**TO:** District of Columbia Zoning Commission  
**FROM:** Stephen Cochran, Development Review Specialist  
*JL for* Jennifer Steingasser, Deputy Director, Development Review & Historic Preservation  
**DATE:** September 21, 2020  
**SUBJECT:** Report on Zoning Commission Case No. 20 – 14 Design Review for Alternative Development Proposals for 5 M Street, S.W.

**Figure 1. Component Sections of Single Proposed Building**

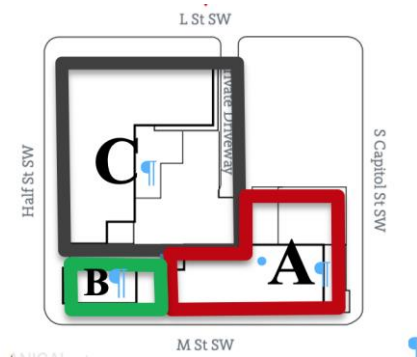
The area labelled “A” at the corner of South Capitol and M Streets would have ground floor retail in both schemes but would be all-office above in the mixed-use scheme and all-residential above in the residential scheme.

The area labelled “B” would be 2 stories high in the mixed-use alternative and up to 13 stories high in the residential alternative. It would provide the meaningful connection between “A” and “C”. Both schemes would include retail space and residential amenity space on levels 1 and 2 of

The area labelled “C” would be a 13-story residential tower in both schemes.
